Westinghouse
Electric Corporation

DCP/NRC1151
NSD-NRC-97-5441
Docket No.: 52-003

SUBJECT: RESPONSES TO QUESTIONS OF CONTAINMENT SCREENS AND PAINT

Attached are responses to questions related to plugging of screens and safety classification of paint. These questions were included in letters from the NRC dated July 30 1997, August 21, 1997 and October 7, 1997. Included with the response are draft SSAR changes. These changes will be included in SSAR Revision 18.

Figure 480.1078-1

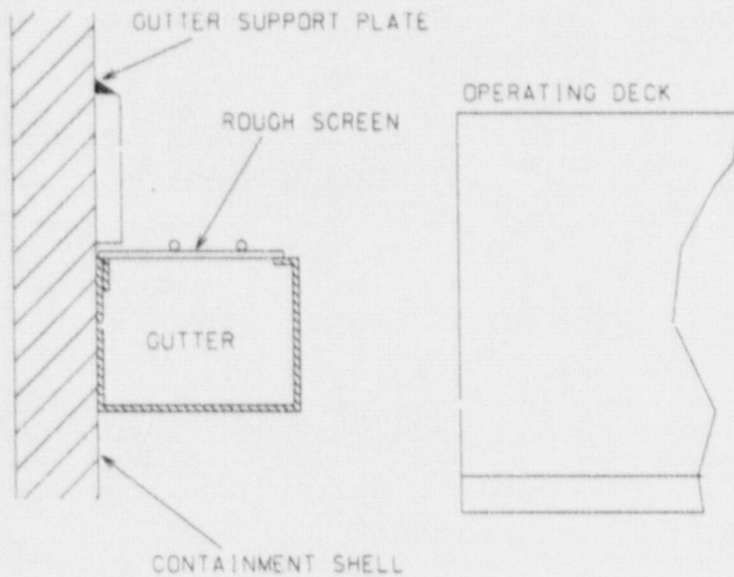
Provide a description and drawings(s) of the flow path of the condensate on the containment wall (following a PRHR actuation or LOCA) as it returns to the IRWST. Include the valves which must close and the screen

The flow path from the containment inside surface to the IRWST gutter is shown in the attached Figure 480.1078-1. A rough screen is provided on top of the gutter to prevent clogging of the gutter or the collection point overflow into the IRWST. The gutters gather condensate from the circumference of the containment and from the operating deck. The gutter drains this condensate to two collection points which are illustrated on SSAR figure 6.3-2. Drains from these collection points, normally allow the condensate that may form during normal plant operation to flow to the waste sump. A PRHR heat exchanger actuation signal closes redundant safety-related valves in the drain line to the waste sump, shown on SSAR figure 6.3-2. Closing of one of these valves forces the condensate to overflow from the collection points into the IRWST. The IRWST screens are shown in SSAR figures 6.3-6 and -7.

Figure 6.3-8

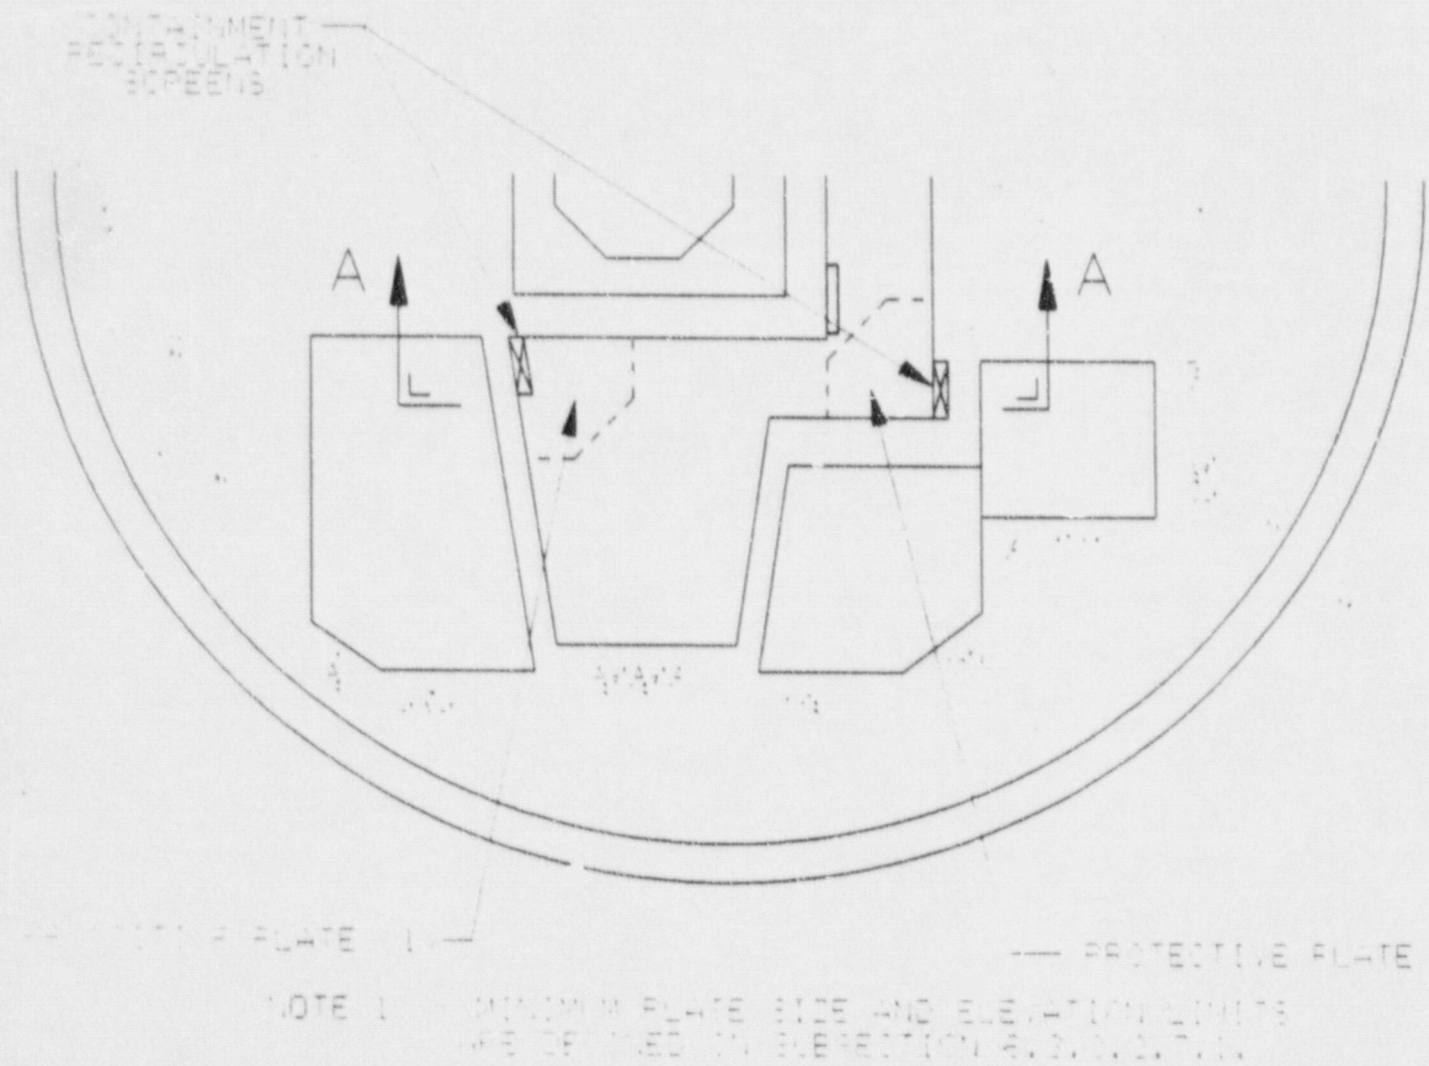
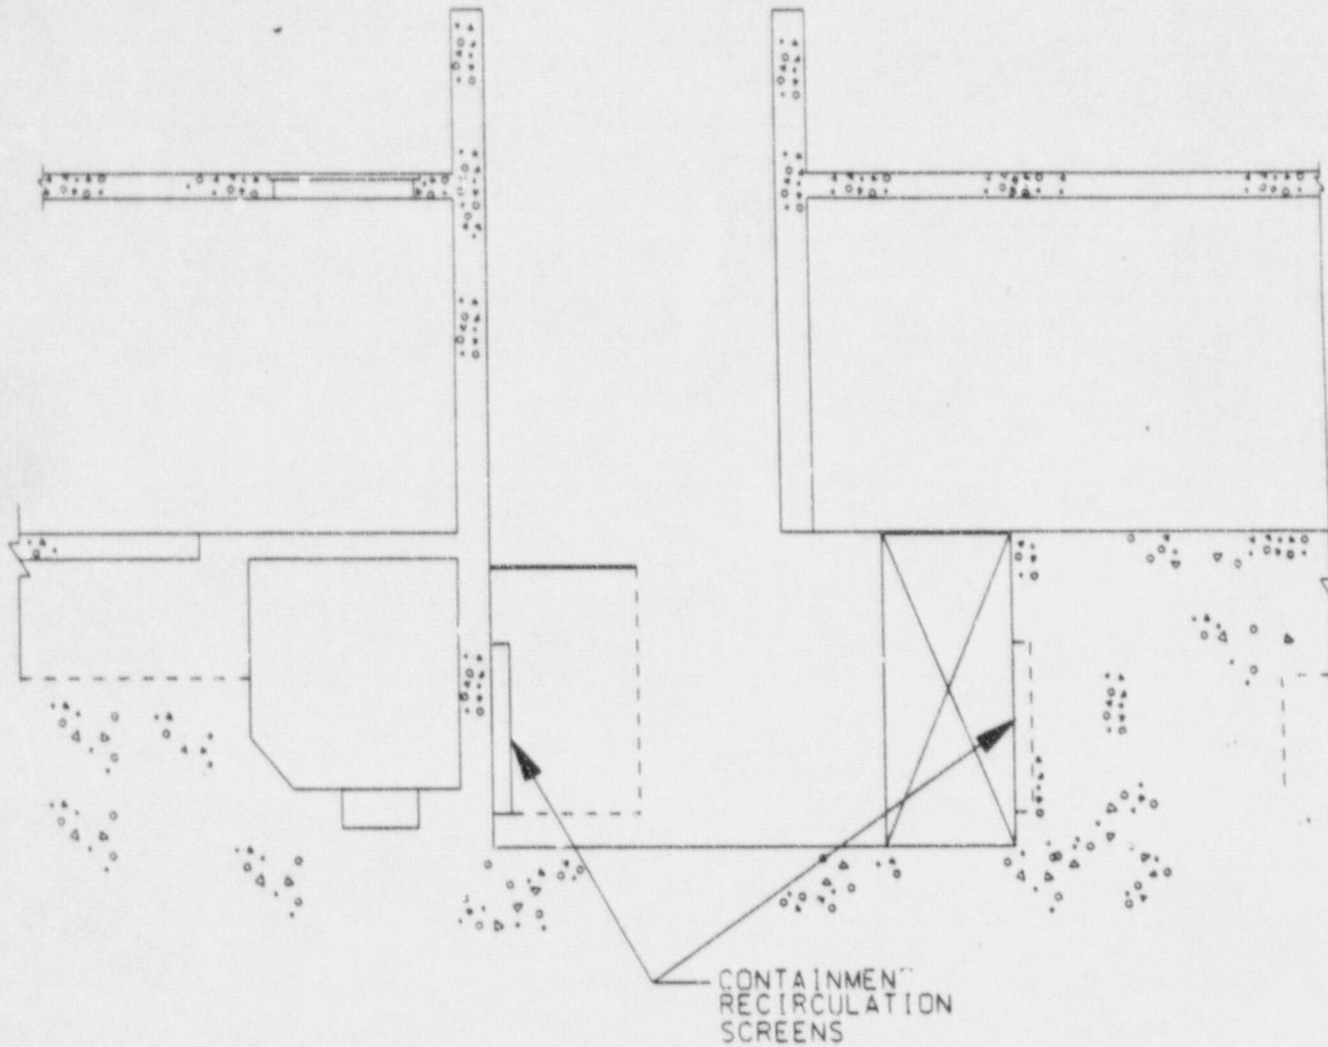
Describe the basis for sizing the IRWST screens and recirculation screens.

- (a) Include a discussion of flowrates through the screens and approach velocities with and without the nonsafety RHR pumps available.
- (b) What type of debris are assumed to be present for the purposes of determining an acceptable loss across the recirculation screens. In particular, what quantity of unqualified coatings, i.e., those which are not intended to remain attached to their substrate following a LOCA are present in containment? Such coating may be applied to commercially purchased electrical equipment, motors, etc. Verify that no fibrous insulation or particulate insulation is used in any area of the containment that contains high energy lines or may be impacted by the discharge of high energy lines. If this not possible, verify that the amount of fibrous or particulate insulation used in containment cannot adversely impact IRWST or recirculation flow during an accident. Information gathered while resolving the boiling water reactor (BWR) strainer blockage issue shows that a combination of fibrous material with particulates (e.g. paint chips, rust, etc) can produce a much higher pressure drop than that due to the fibrous material alone. If fibrous material can reach the IRWST or recirculation screens discuss how this effect is taken into account.

- (c) Even a well-conceived and through foreign material exclusion program may leave behind some material capable of blocking portions of the IRWST or recirculation screens. Has any allowance been included in the screen sizing for such material.

The containment recirculation screens are oriented vertically along walls above the loop compartment floor (elevation 83 feet). Figure 6.3-8 shows a plan view and Figure 6.3-9

shows a section view of these screens. Two separate screens are provided as shown in Figure 6.3-3. The loop compartment floor elevation is significantly above ~~(11.5 feet)~~ the lowest level in the containment, the reactor vessel cavity, which is 11.5 feet below. The bottom of the recirculation screen is two foot above the floor, providing a curb function.

Revise figures 6.3-8 and 6.3-9 (attached) to show plates over screens.
